Briar Vale Flood Prevention Scheme – Discharge of Conditions - 19/00306/COND

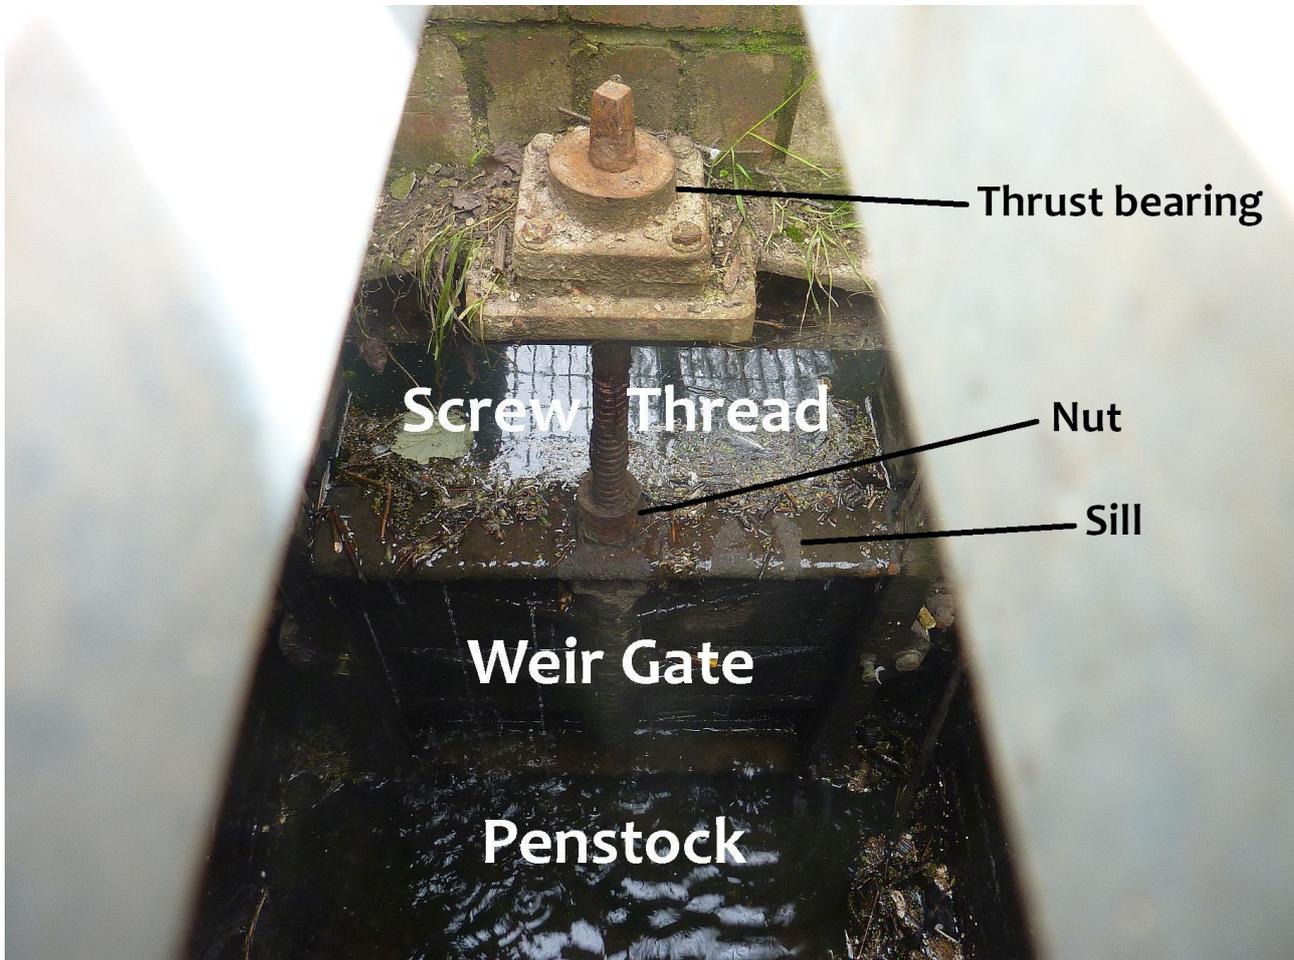
Contrary to Mr Lillie’s statement, the “adjustable penstock weir “ has remained jammed since Owen Pugh raised it by some 5cm and were unable to return it to the ‘as found’ position. The in-operability of the sluice gate has been confirmed most recently on 5 April, 2019 when workers from NWL attempted to move it (under a request from the NTC project engineer, Mr Burnett).

The photograph of the weir gate above has previously been forwarded to Mr Burnett with some ideas for a way to effect a repair.

Without the capability to easily open the weir gate it is not possible to maintain the lake level to avoid flooding of the surrounding area as continues to happen with or without the additional flow from the Briar Vale storage basin. The regular blockage of the wire mesh over the external grille on the lakeside of chamber 1 causes a drop in water level to the inside of the grille. This has been estimated as typically 10cm – 12cm. A long establish formula for flow over a weir reveals that the flow rate varies with the depth of the water above the sill to the power of 1.5. Thus, the flow rate for a depth of 6cm compared with 1cm is 15 times as much. This explains why the lake level drops so slowly compared as to how it was before the weir gate was jammed in the position left by the Owen Pugh work.

4. Repair and maintain the weir gate #. The maintenance should include regular raising/lowering over its full range to ensure it can be opened in the event of an impending storm in the lake’s catchment area. # - or replace it.

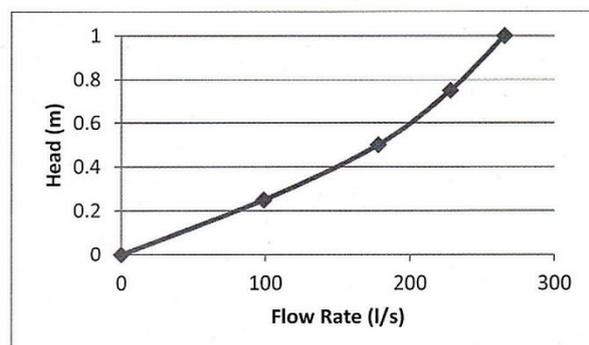
NWL provided the graph above in response to the question about the outlet flow rate from the lake after its re-direction to the North Sea. **It ignores any blockage of the outlet** and clearly assumes that the water level within the two outlet chambers is the same as that on the lakeside of the grill. (It ignores the position of the weir gate or assumes it to be lower than the invert of the notch in chamber 1.) **It takes no account of any drop in water level through the wire mesh and over the weir gate.**
